AP 545133

RE: **Percolation Certification Revised Plan
12405 Kondrup Drive**

Re: **12405 Kondrup Drive**
Percolation Certification Revision Plan

PERCOLATION CERTIFICATION REVISION PLAN

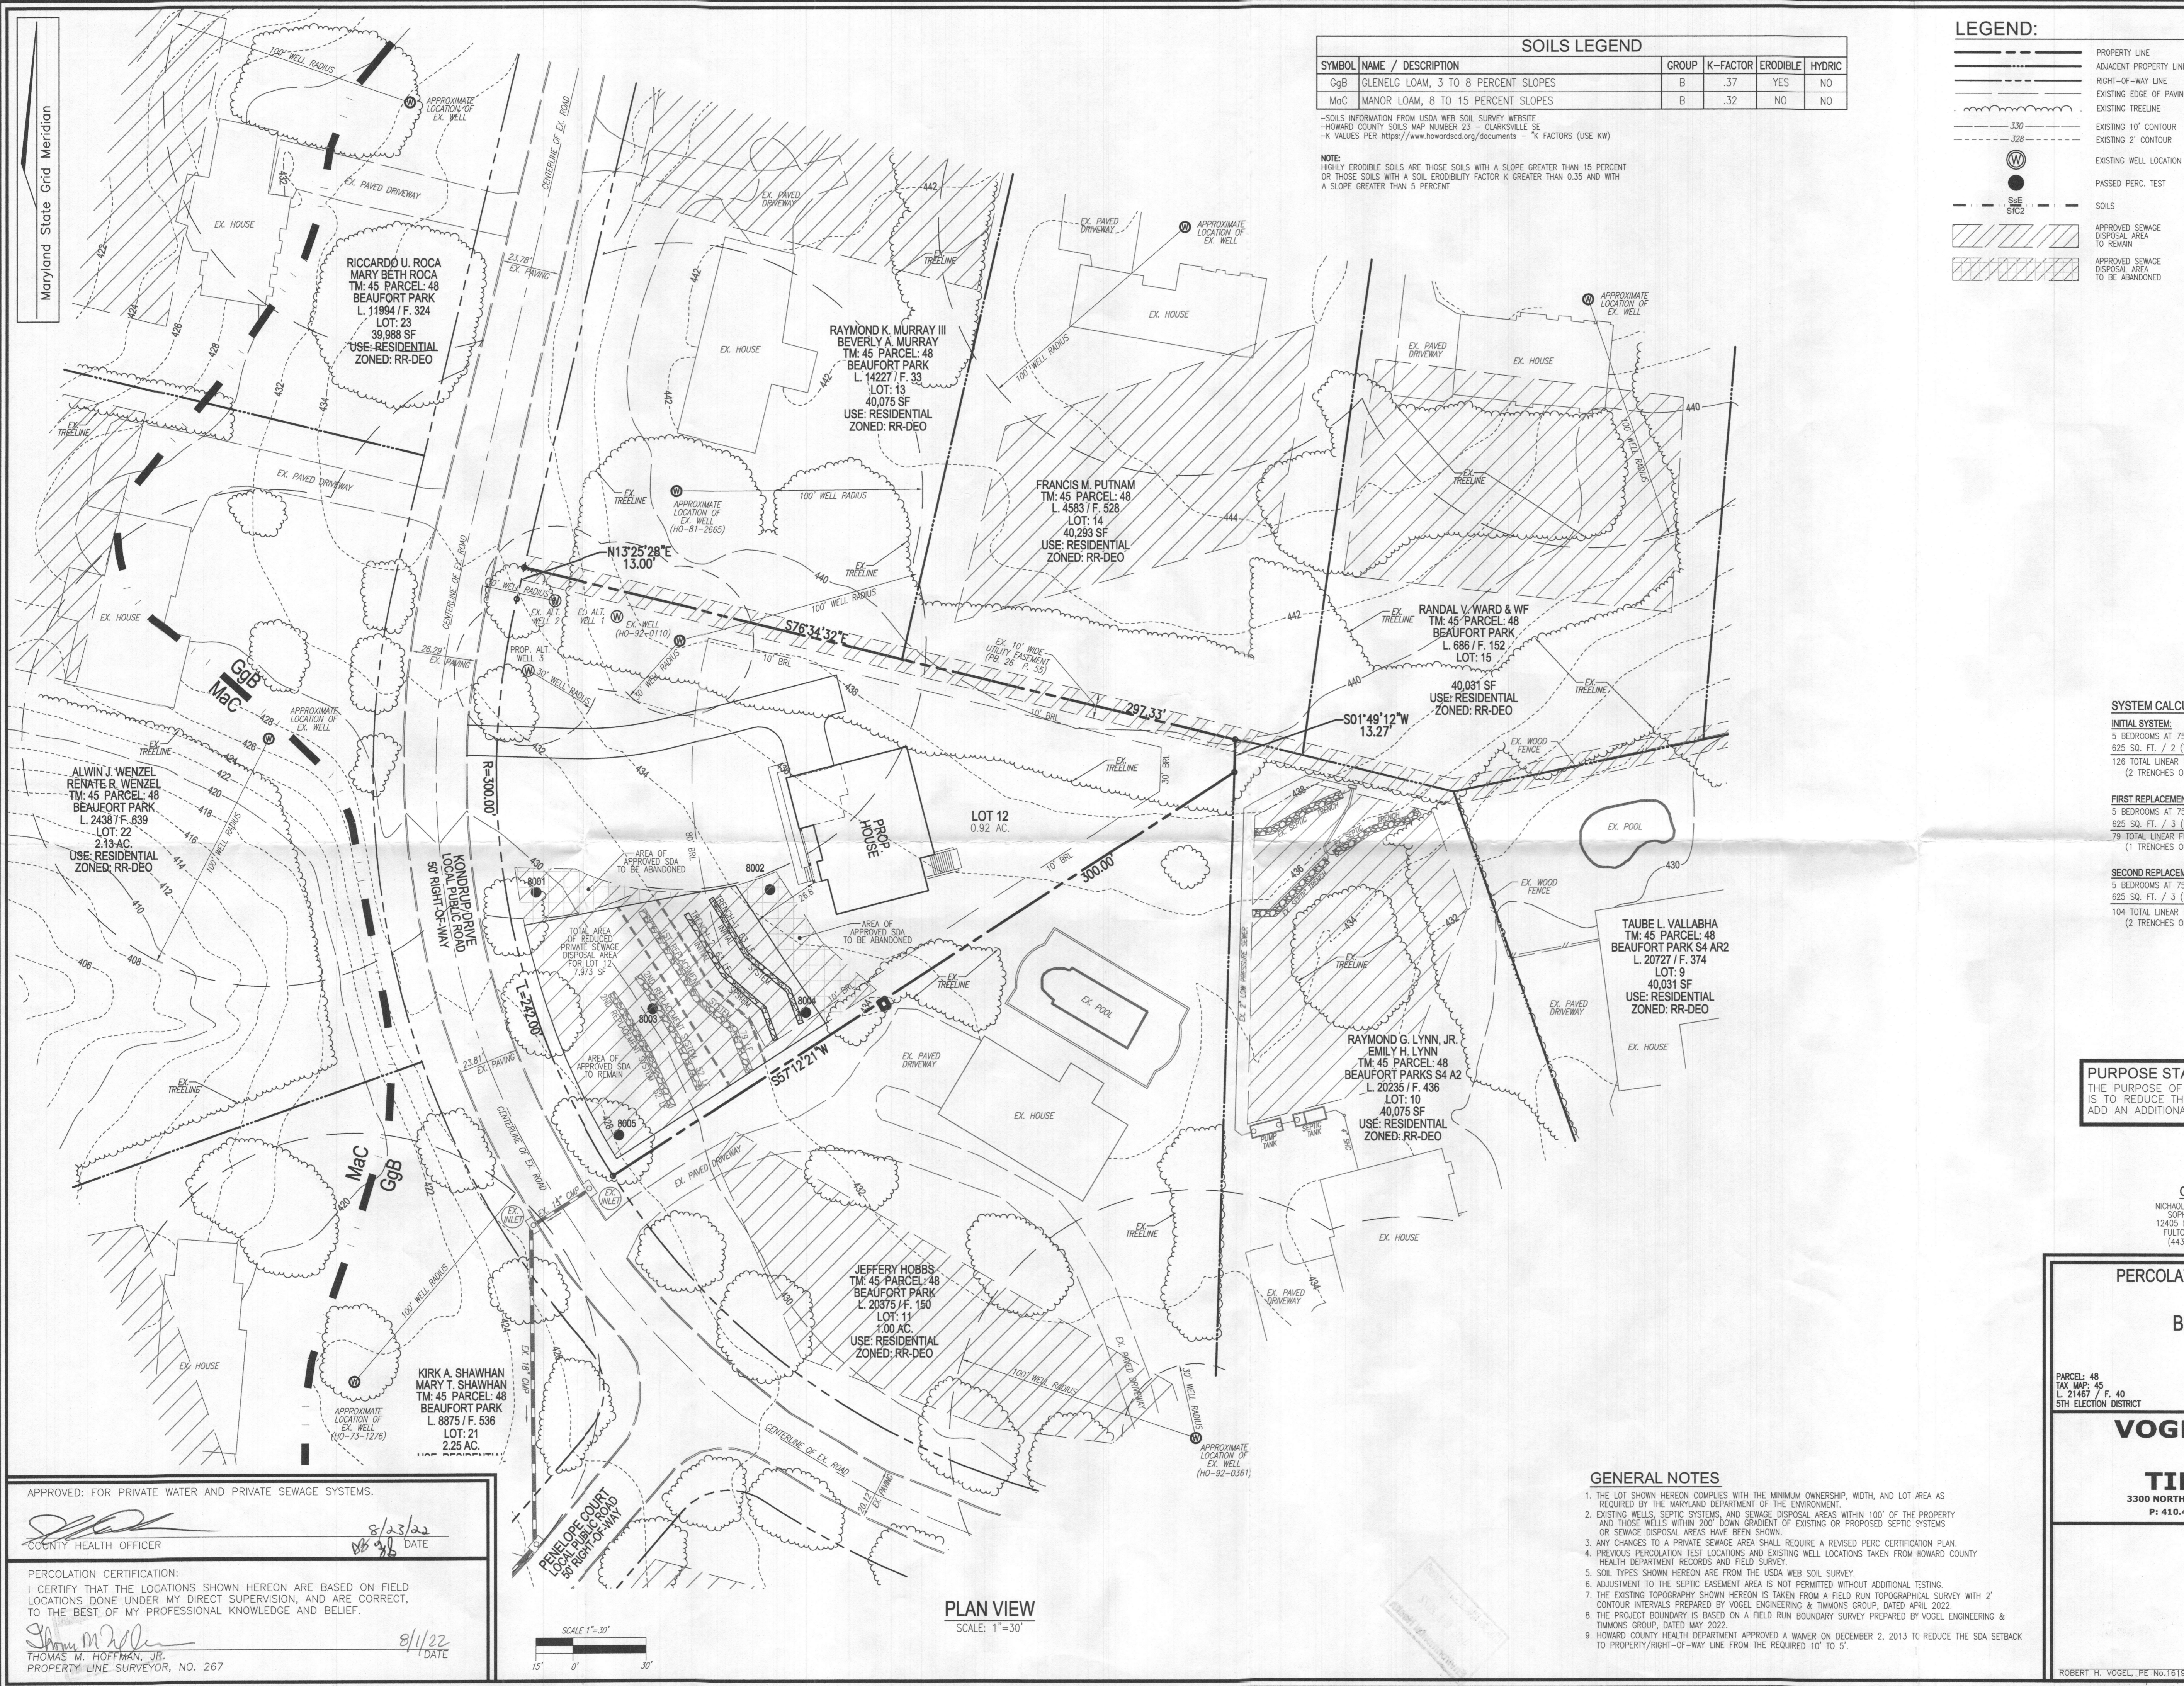
Attached is the sheet the builder provided to us which is signed. He was proposing to adjust the sewage easement lines. I tried to add the original lines back (shown in red).

But this is the plan I saw which was signed. Just sending for your information only.

We have a bit of a dilemma. The attached perc cert plan was prepared by FSH and approved by Health (this one is not signed). The signed perc plat is dated 12/2/2013. The perc cert plat showed the septic easement at 5' distance to property line and right-of-way line. The installed well and the backup well sites are less than 50' apart. I understand Dana is requesting that we revise the approved SDA to 10' from property line and right-of-way. The resulting SDA would be 7,800 sf. If we need to provide 1,500 sf well envelope we are then down to 6,300 SDA. Please let me know if we can chat about this.

Hi Rob. I'm not seeing a signed version on the plan in our file, but our records indicate we signed a copy. Assuming it is the same as this unsigned version in the scanned file, just add a note on your revised perc cert stating that we approved a waiver to allow the SDA to be 5' from the property line. Property line must be staked out prior to septic system installation. Also, we are ok with the well separation as shown on this old plan, but it seems you could add a well location up by the top of the driveway maybe. 4 locations would be better than 3 if the separation is less and given the water scarcity in this neighborhood
Jeff

PERCOLATION CERTIFICATION REVISION PLAN

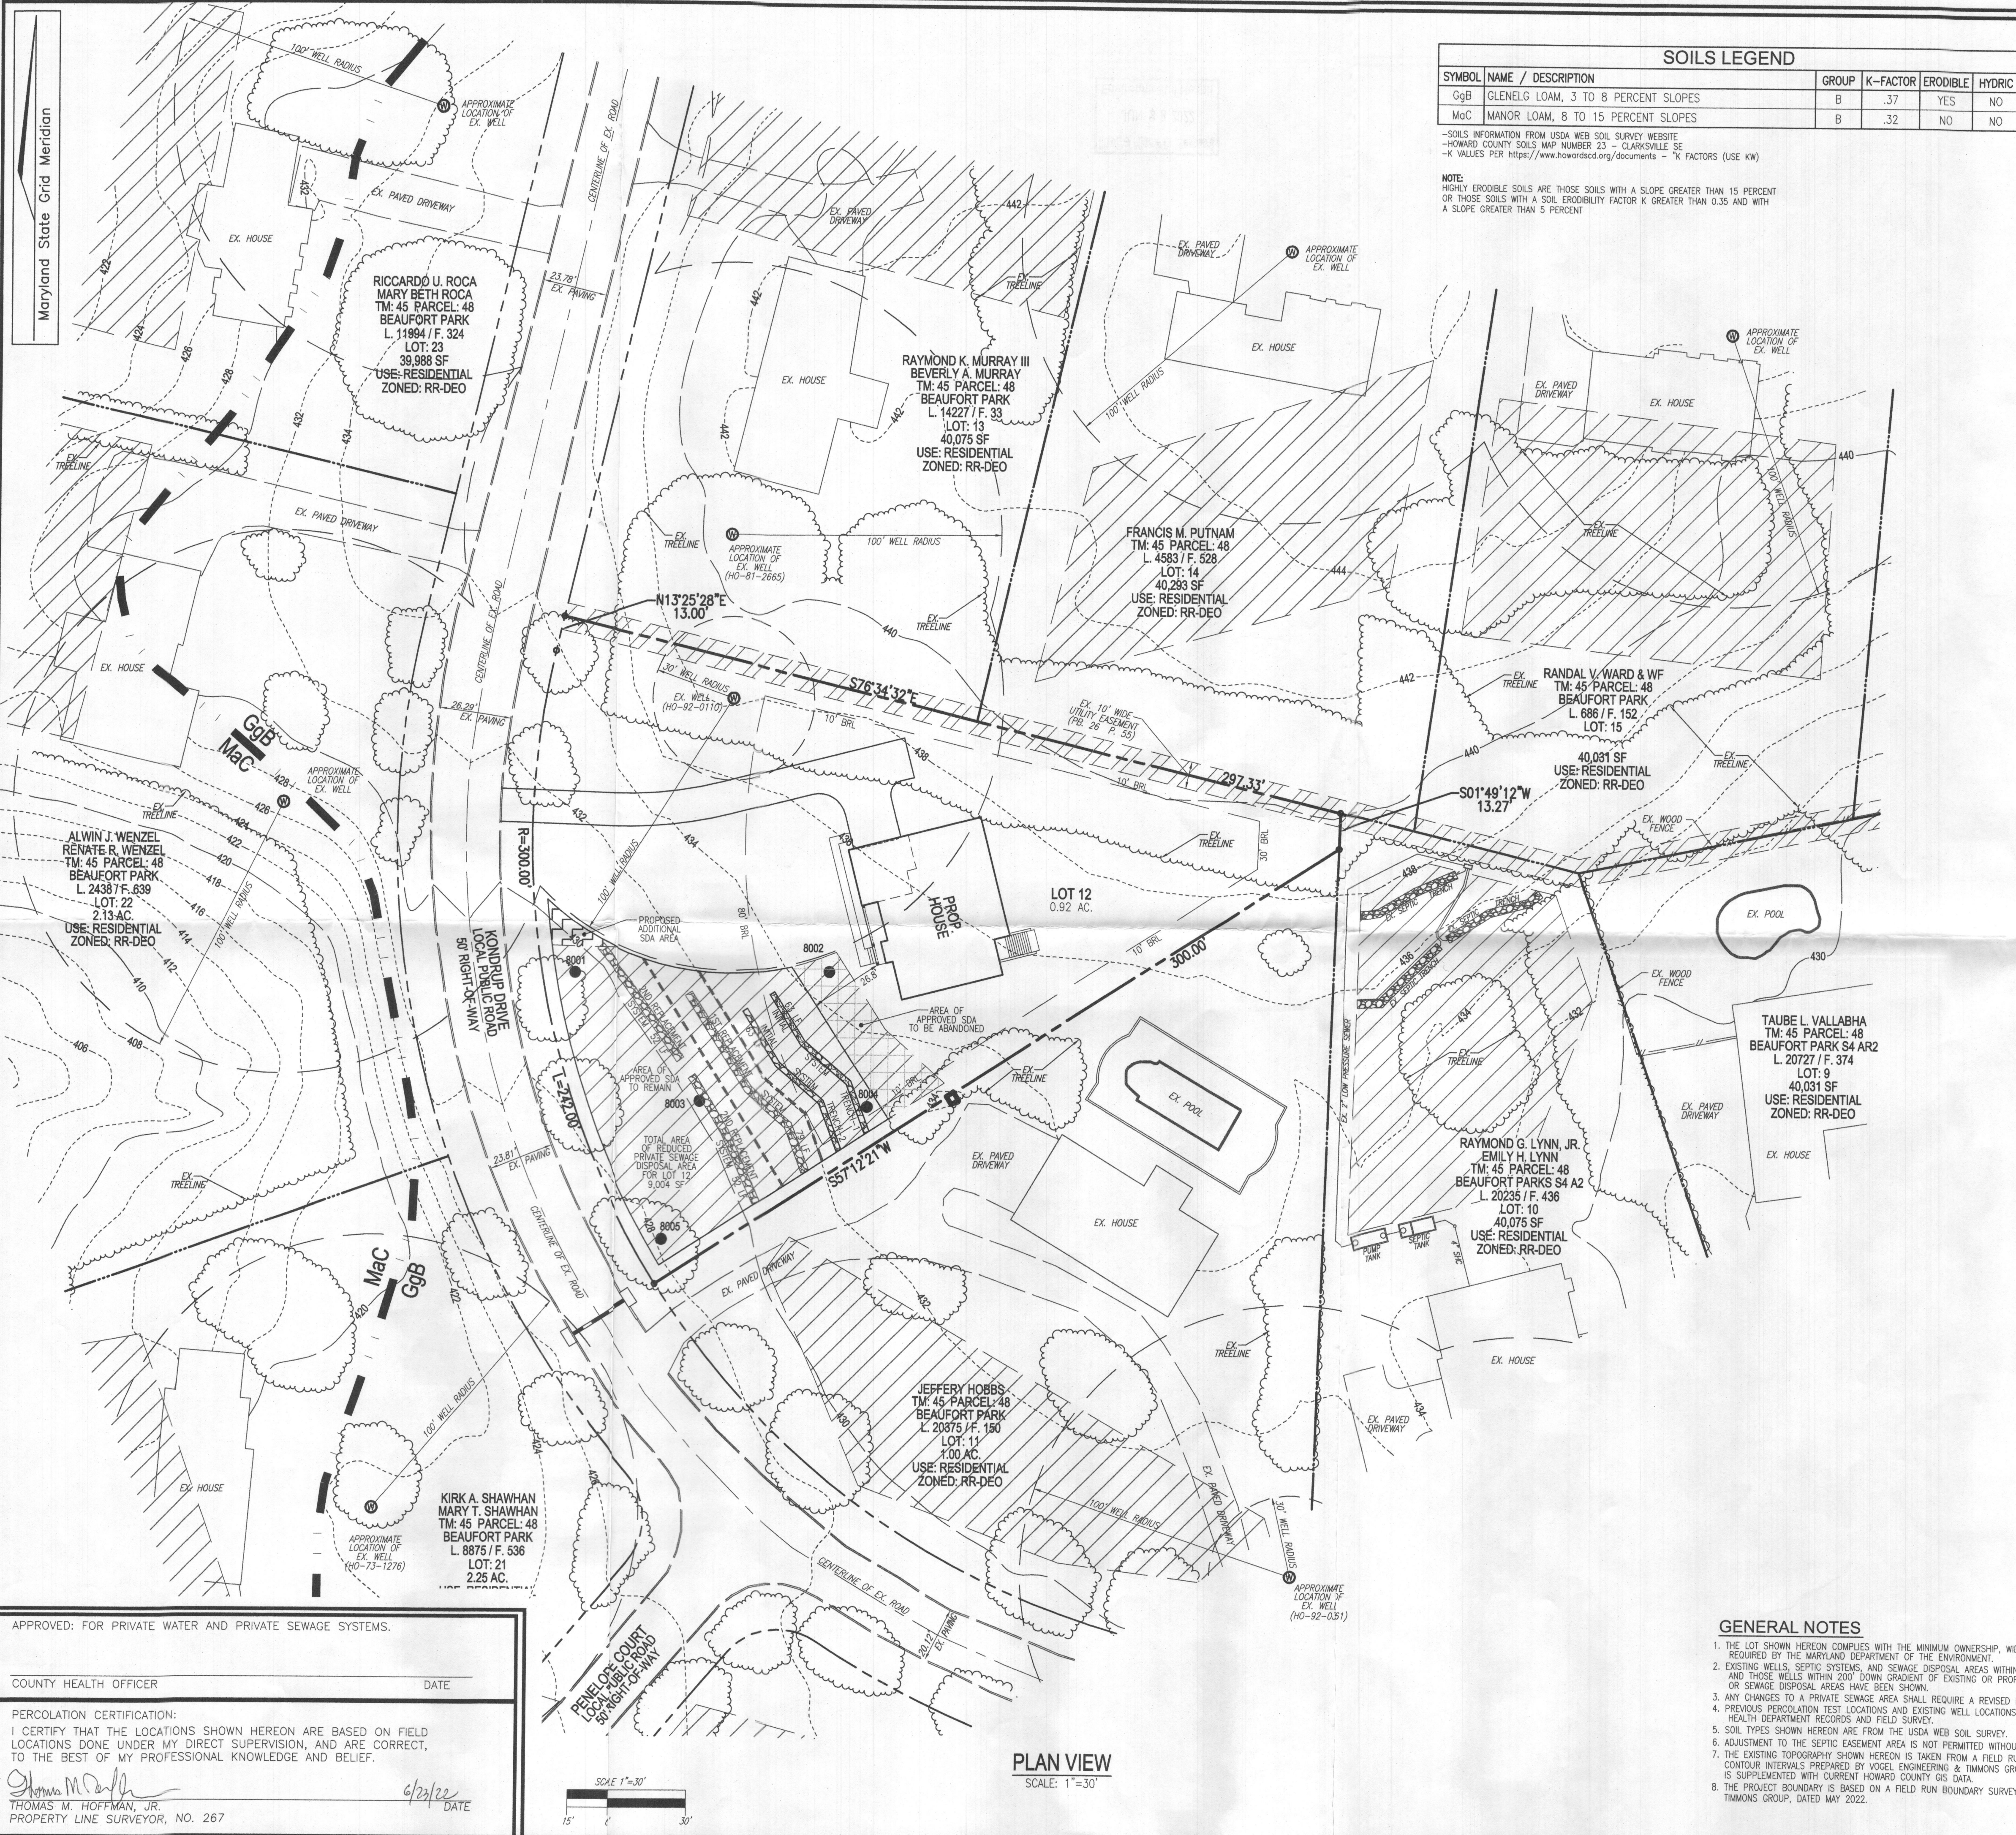
In addition to my coworkers comments regarding the PC Plan for 12405 Kondrup Drive (see attachment), I noticed on the OSDS Plan that the SDA is 5 feet from the property line. You will either have to ask for a waiver to reduce the setback or adjust the SDA to 10 feet.

In line 7 on your percolation plan it is stated that the area is not field located. This project must be field located and verified by an engineer or surveyor. The following statements must be added to support your plan.

- The topography of this plat is taken from _____ and is verified to accurately represent the relative changes on the subject property. By Vogel Engineering.

Also, a purpose statement indicating the purpose of the plan must be included on the plan.

And you must show two alternate well locations on the plan.

Remember the wells must be 50 feet apart or you must show a 1500 sq. ft. well box.

1. General note #7 states the topography is taken from a field run topographical survey performed by Vogel Engineering + Timmons Group, dated April 2022.

2. A purpose statement is located on the right side of the drawing, just above the Owner/Developer information.
3. The three well locations, as shown on the Percolation Certification Plan done by FSH and signed by the Health Department on 12/2/2013, are shown, and we have added a 4th alternate well location per the request of Jeff Williams. See email from Jeff Williams on July 29th, 2022.

4. The SDA is shown with the 5' setbacks to the property line and the right-of-way line as recorded on the Percolation Certification plan prepared by FSH and signed by Health on 12/2/2013. We have added a general note stating that Health approved a waiver to reduce the setbacks to 5' on December 02, 2013. Jeff Williams asked us to add this note to the plan. See email from Jeff Williams on July 29th, 2022.
